**From:** Hansen, Edward J., EMNRD  
**Sent:** Tuesday, May 21, 2013 9:40 AM  
**To:** Hack Conder (hconder@riceswd.com)  
**Cc:** Leking, Geoffrey R, EMNRD; Katie Jones <kjones@riceswd.com> (kjones@riceswd.com); Laura Pena (lpena@riceswd.com); Lara Weinheimer (lweinheimer@rice-ecs.com)  
**Subject:** Remediation Plan (1R-488) Additional Delineation Approved - Vanguard Abo SWD F-31 Site

**RE: "Further Delineation Request"  
for the Vanguard Natural Resources, LLC's  
Abo SWD F-31 Site  
Unit Letter F, Section 31, T16S, R37E, NMPM, Lea County, New Mexico  
Remediation Plan (1R-488) Additional Delineation Approved**

RE: **Further Delineation Request**

**Abo F-31 SWD (1R488): UL/F sec. 31 T16S R37E**

## Figure 1

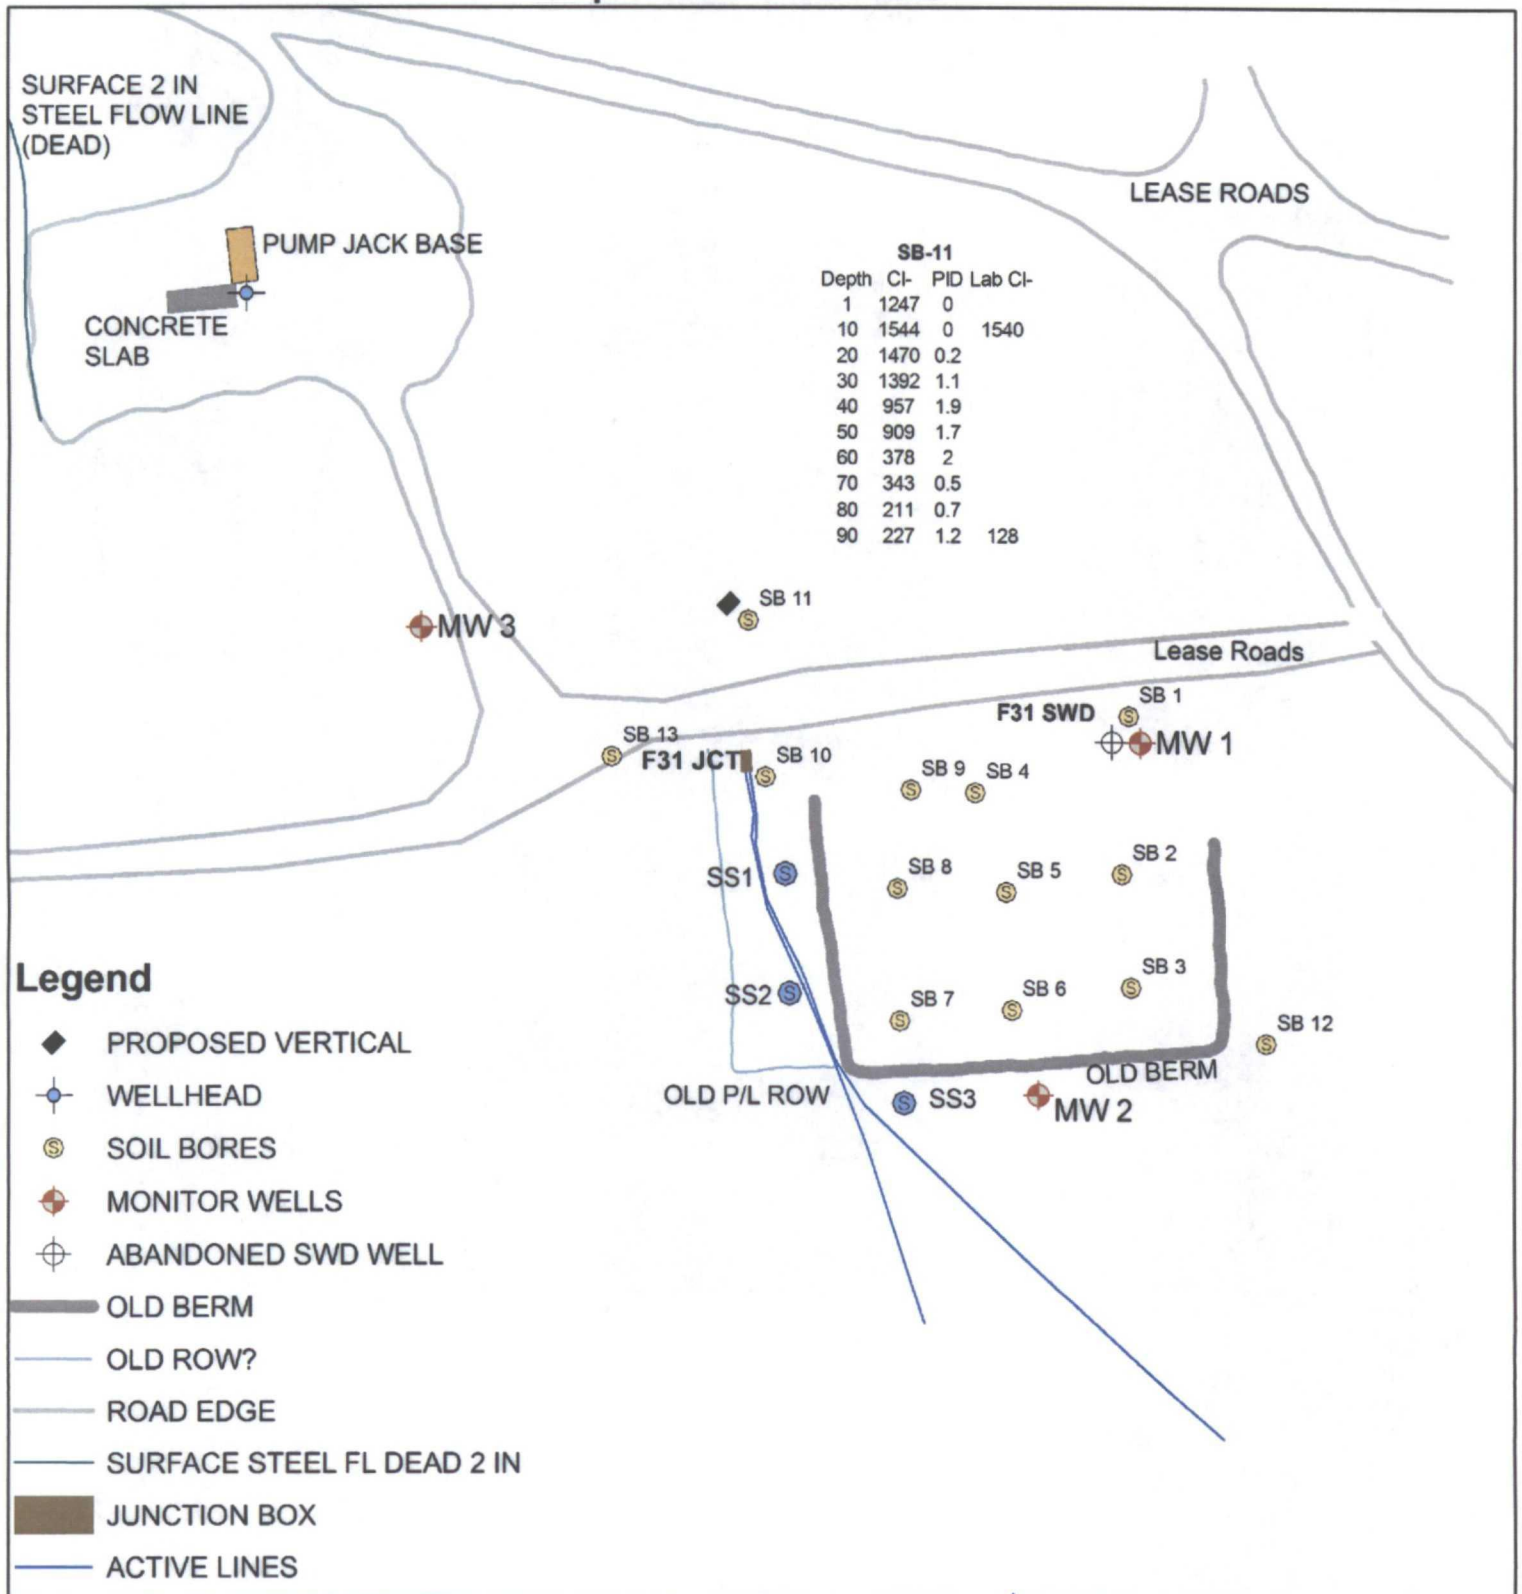
Per a conversation with the City of Lovington conducted on March 18<sup>th</sup>, 2013, concerns were raised over the level of chlorides associated with SB-11. These concerns were discussed with NMOCD on April 18<sup>th</sup>, 2013. Based on these conversations, RECS recommends the installation of verticals northwest of SB-11 (Figure 1). Verticals will be installed vertically and laterally to delineate residual chlorides from samples taken using a backhoe. Vertical sampling will be conducted until three samples occur in which the chloride concentration decreases and the third sample has a chloride concentration of  $\leq$  250 ppm or until vertical sampling is unfeasible given the range of the backhoe. Lateral sampling will be conducted to the northwest until a decrease is observed in chloride

concentrations between lateral verticals at similar depths or safety concerns impede further lateral delineation. Representative samples from each vertical will be taken to a laboratory for confirmatory analyses of chlorides.

The New Mexico Oil Conservation Division (OCD) has received the Further Delineation Request for the Abo SWD F-31 Site, dated May 14, 2013, and has conducted a review of the request. The above-referenced request, submitted in fulfillment of 19.15.29 NMAC (Rule 29, formally, Rule 116), indicates that Vanguard Natural Resources, LLC (Vanguard) has partially met the requirements of 19.15.29 NMAC for this site. Therefore, the OCD hereby conditionally approves the proposed recommendations for this site:

Vanguard must submit to the OCD a corrective action plan within 90 days.
